BenFab, Inc.
13 S. Highland Ave Lansdowne, PA 19050
Phone: 610-626-9100 Fax: 610-626-9200
www.benfabrailings.com

Sullivan Triad Building
200 Renaissance Blvd
King of Prussia, PA

AMC Georgetown
TYPICAL SHOP
DRAWINGS

PROPOSED CHANGES TO #3.1 OF "VERTICAL POST MOUNTING GUIDELINES" FROM SHEET A503

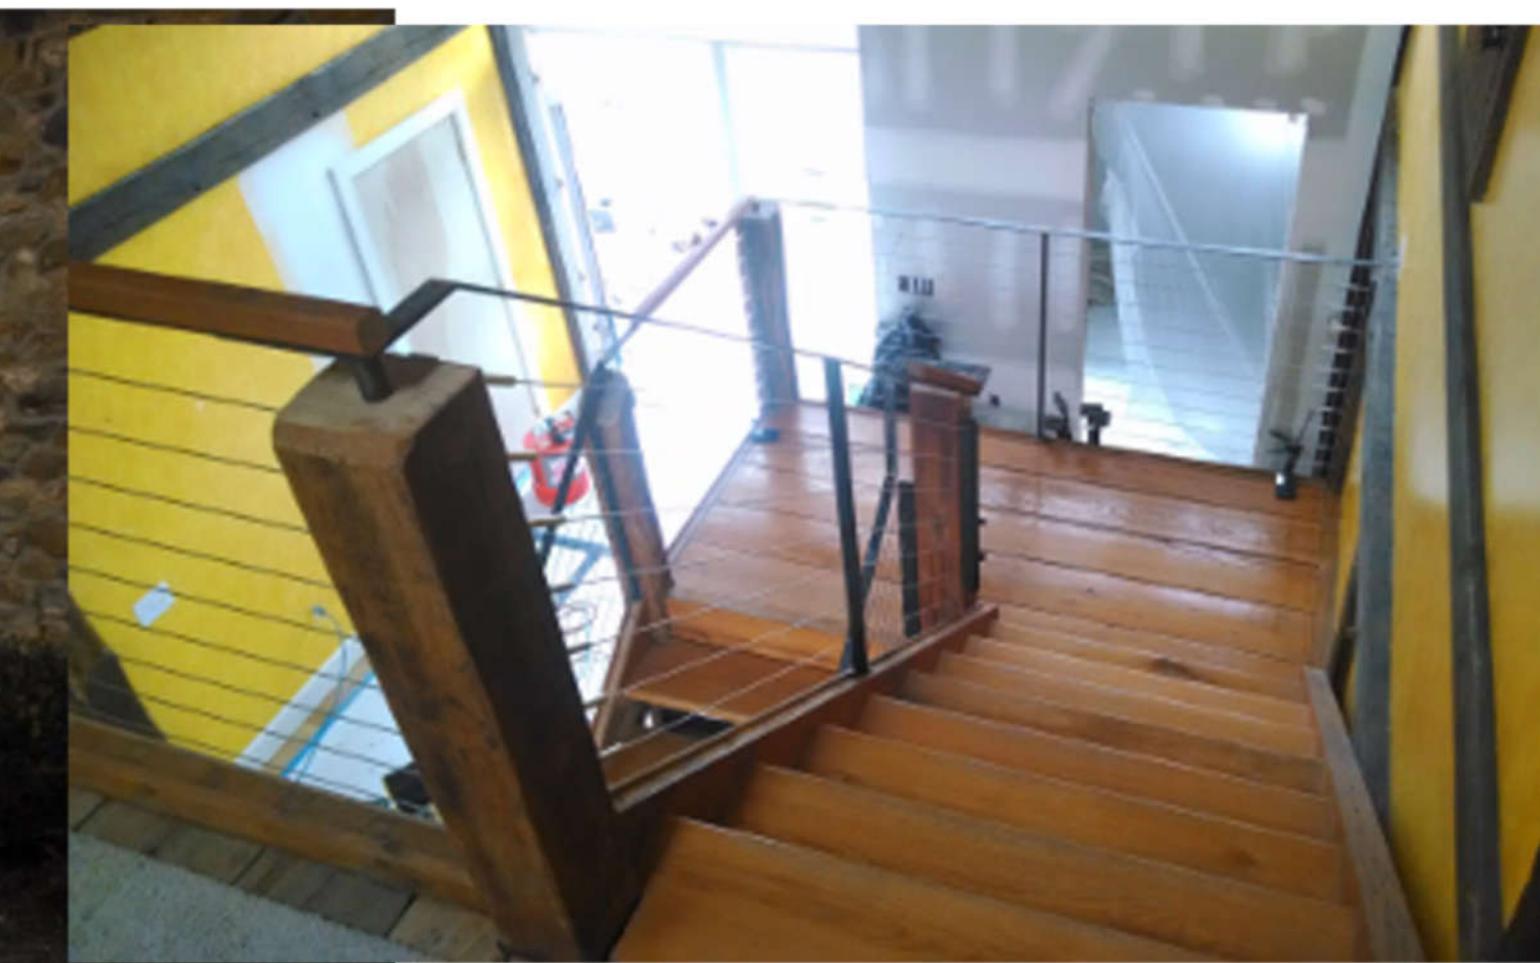
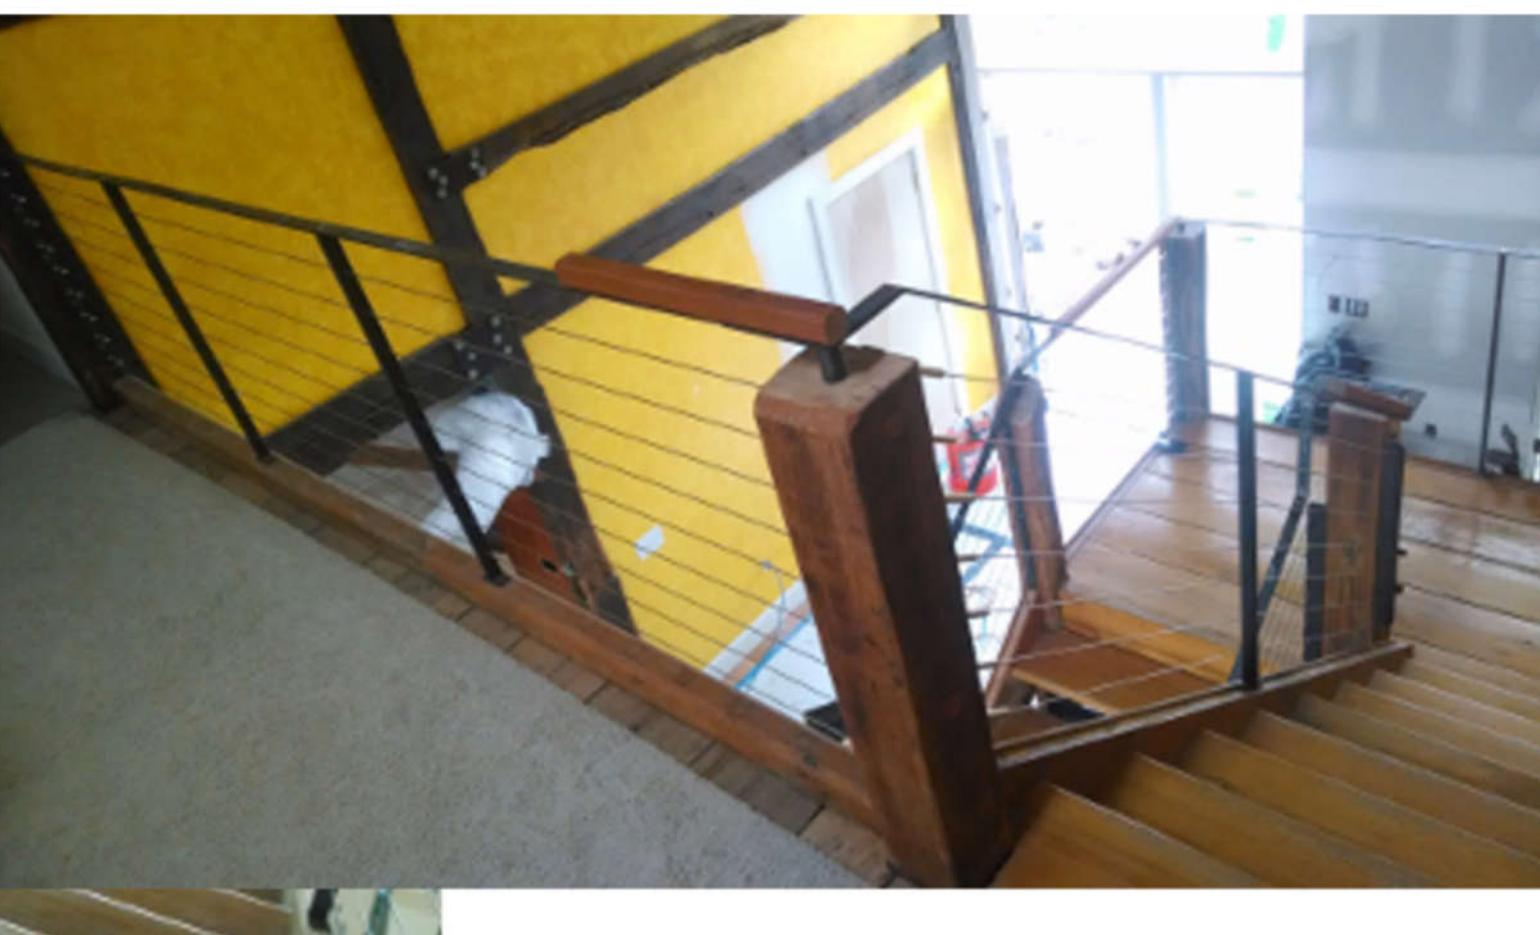
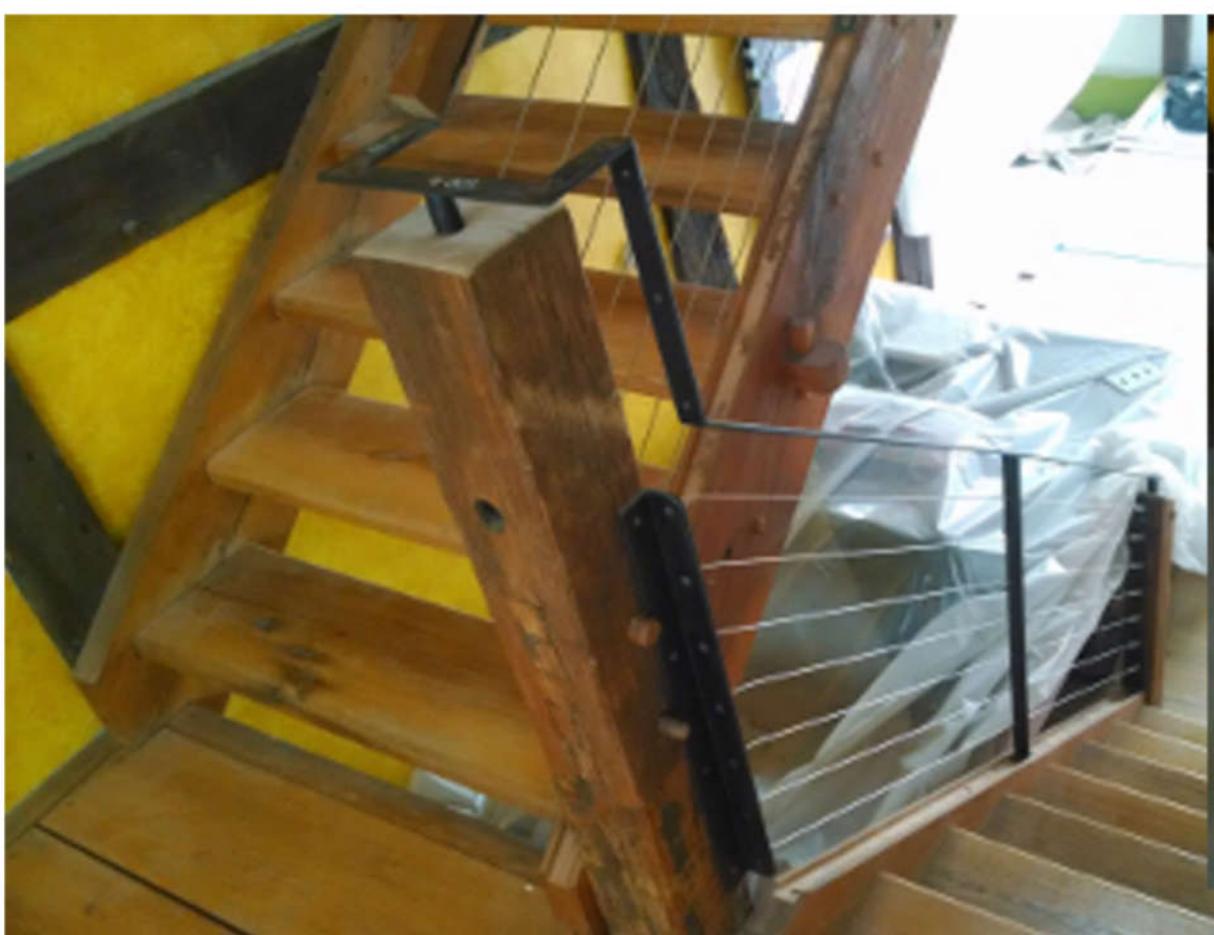
- We would like you to consider not requiring escutcheons on top of the 6x6" baseplates. I've included a photo of a previous installation like this. I don't happen to think that this is an aesthetically pleasing look. Also, since the escutcheons are not attached, and move freely, they have the potential to get kicked and likely scratch the paint on the post. We're still happy to put them on if you require it.

- If we go with the escutcheons on top of the baseplates, I would like to propose that we move the post farther away from the edge of the baseplate in order to make room for the entire escutcheon. If you look at the long guardrail in the same photo, you will see that, despite the fact that this particular railing did not have baseplates, you can still see that, because of the plastic lighted nosing, there is still plenty of room for the entire escutcheon, without the need to trim them. Also, if we do trim them, there is nothing to stop them from spinning around.

- Where the offset 6x6" baseplates attach to a plywood floor, the detail shows all four screws on one side of the post. I would like to propose that we keep the screws in the corners. This way we only have to fabricate one kind of baseplate for the entire theater.

- If the scenario arises that is described in #2 of the "Vertical Post Mounting Guidelines" from sheet A503, we will need to know as soon as you are aware that the situation is likely to arise. The logistics of this are not simple, and will require discussion and planning.

- We would like to propose a change to the detail described by #3.1 of the "Vertical Post Mounting Guidelines" from sheet A503. The primary reason for proposing a change is that method described in #3.1 is that it is logically difficult. As it stands, carpet can't be installed until after we install railings. We can't measure for railings until the Structo-Crete is in place, and the window of time between the Structo-Crete being installed and the carpet being installed is too narrow. This will likely cause delays in the installation of carpet.
